REVISED

| Request | - | Preliminary Drawing for Stoneridge Farms

Plats 9-10 |

PRELIMINARY DRAWING
SPRINGFIELD TOWNSHIP
LUCAS COUNTY PLANNING COMMISSION
REF: S-15-25
DATE: September 24, 2025
TIME: 9:00 a.m.

REVISED PRELIMINARY DRAWING

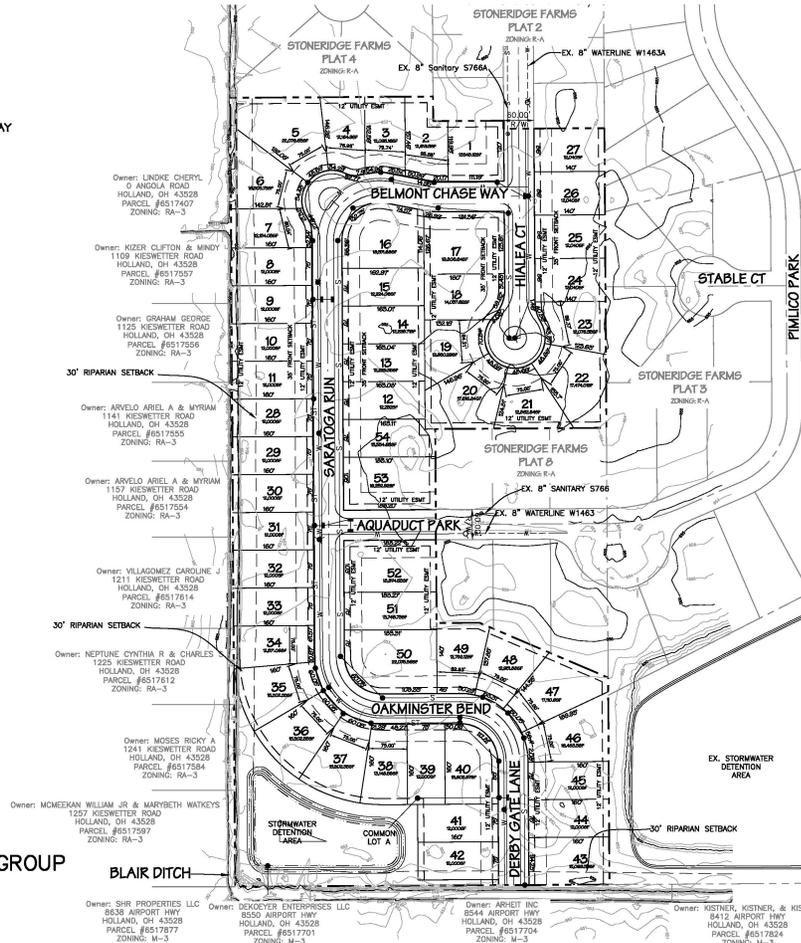
- ~~1. Lot measurements must be provided for lots 2, 7, 34, 38, 47, and 19-13 on the drawing to determine if the drawing is complaint with the R-A zoning district.~~

15. There is already a street named Churchill in this subdivision group, so Churchill Bend needs to be renamed.
16. The vicinity map is incorrect.
17. Blair Ditch now has a 25' petition easement that may extend beyond the 30' riparian setback.

- ~~25. Belmont Chase and Derby Gate need USPS recognized suffixes. “Chase” and “Gate” alone are not valid. Street names shall with suffix are limited to 18 characters.~~

REVISED DRAWING REFLECTS COMMENT

REVISED DRAWING REFLECTS COMMENT
